Bannerman Road Final Engineering Report
Continuing Concerns/Issues from “Responses, January 7, 2022”

Chuck McClure, President
McBride Hills HOA
January 10, 2022
crmclure999@yahoo.com

The second image shows the approximate right-of-way boundary in 'yellow' – the 'fuchsia' line indicates the known private property boundary.

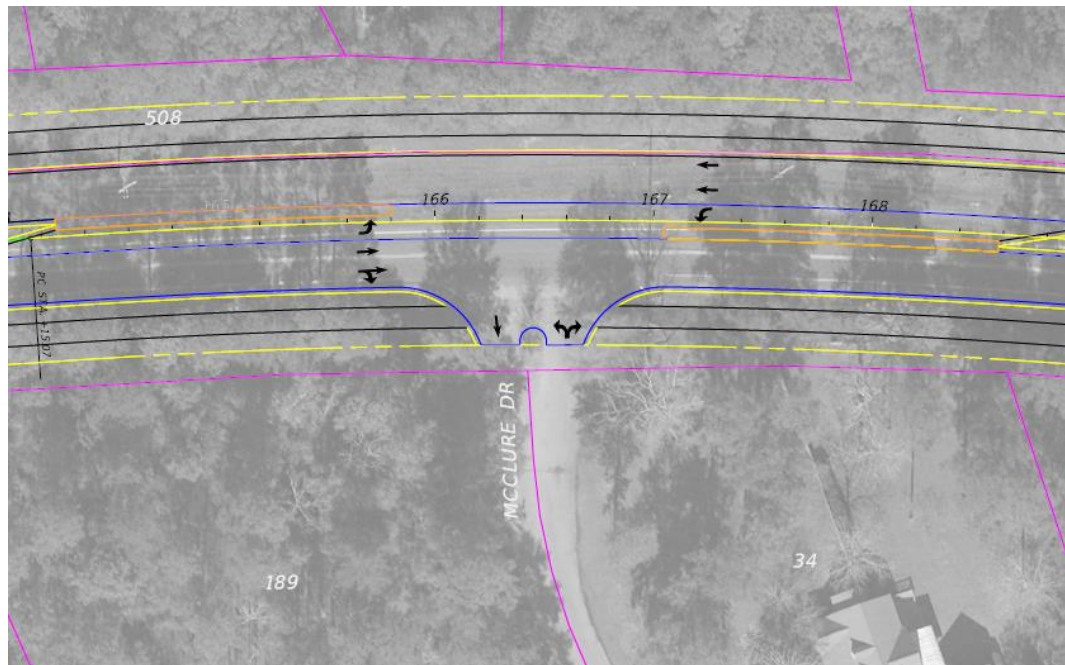
- Where, EXACTLY, does the right of way end into McClure Drive?
 - Please see images below: The first image displays the current McClure Drive signage indicating private ownership.

- Does the project expect the three HOAs to be responsible for improvements on McClure Drive that are required as a result of the widening of Bannerman tht go beyond the right-of-way?
 - o The Bannerman Road project will be designed to tie into the existing side-street, similar to other roadway projects connecting to neighborhood streets. If the McBride Hills roadways are impacted by the connection of

project improvements to the neighborhood roads, our project team will work with the residents of McBride Hills to develop a solution.
